**Badger 210730_QS-14A_Final
A303 Amesbury to Berwick Down
PIM Clashes review report**

HE551506 - A303

Title
HML vs HSNAssignee
Steve Smith
Reporter
Niteen PawarProject
HE551506 - A303Created
26/Feb/2021
Deadline
26/Feb/2021

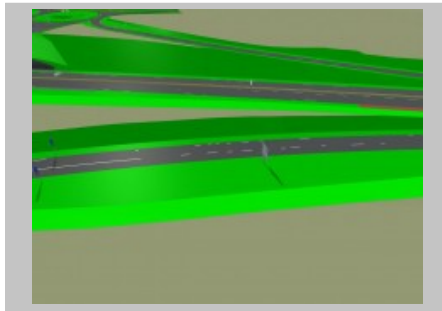
Steve Dimmock - Please confirm if the sign post is designed as passively safe column and does need VRS protection.

The sign posts are passively safe

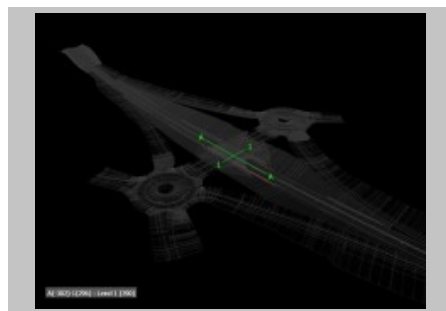
Please, review clash and comment

Please, Steve review and comment clash

This isn't a real clash as it's the signs post and foundations in the ground

HRR vs HMK: Clash2

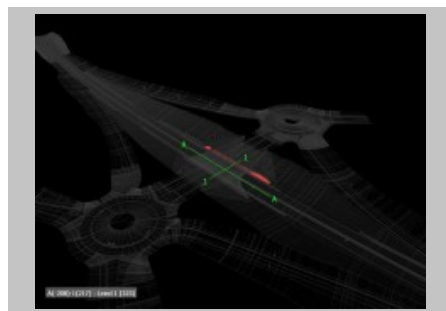
Please, review clashes assigned to you

The barrier will be placed at design setback from the edge of carriageway. This is not a real clash.
